Proposal for amendments to ECE/TRANS/WP.29/GRRF/2008/2 (Brake Assist Systems)

This document is a proposal for amendment to the Brake Assist proposal of document ECE/TRANS/WP.29/GRRF/2008/2 and concerns Brake Assist Systems of Category A with the evaluation of performance being made on line pressure as an alternative to deceleration.

Figure 1b

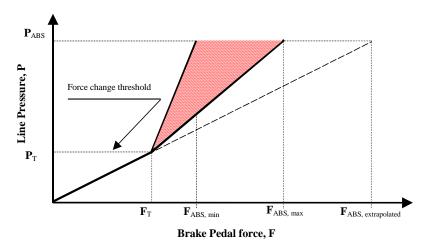
Add an additional paragraph 3.2.5. and amend the title of Figure 1 to read Figure 1a and add an additional Figure 1b.

- "3.2.5. As an alternative, which can be selected by the manufacturer, the pedal force figures for F_T, F_{ABS,min}, F_{ABS,max} and F_{AB,extrapolated} may be derived from the brake line pressure response characteristic instead of the vehicle deceleration characteristic. This shall be measured as the brake pedal force is increasing.
 - 3.2.5.1. The pressure at which ABS cycling commences during the procedure set out in Appendix 1 to this Annex to determine the level of a_{ABS}, shall be noted and averaged.
 - 3.2.5.2. The threshold pressure P_T shall be stated by the manufacturer.
 - 3.2.5.3. Figure 1b shall be constructed to define the parameters set out in paragraph 3.2.5 above."

Problems experienced, particularly with heavier vehicles such as large vans, result from vehicles without brake assist, not following the dotted linear projection of braking performance with increasing pedal forces, that is suggested in Figure 1(a).

This is because the practical deceleration characteristic tends to be curved downwards rather than being linear as shown in Figure 1(a) which increases the task faced by a BAS booster.

The use of brake assist, formed from an Optimised Dual-rate Brake Booster, achieves a counteraction to this curving performance. Whilst the driver does not perceive a sudden jump in deceleration above F_T , increasing pedal effort does show a significant increase in the ratio of brake line pressure increase against pedal force increase. This allows the driver to achieve maximum (ABS limited) braking performance on the dry surface, with a pedal effort which is more than 40% less than would be the case with a standard brake booster. With heavier vehicles, this should qualify as an acceptable BAS.
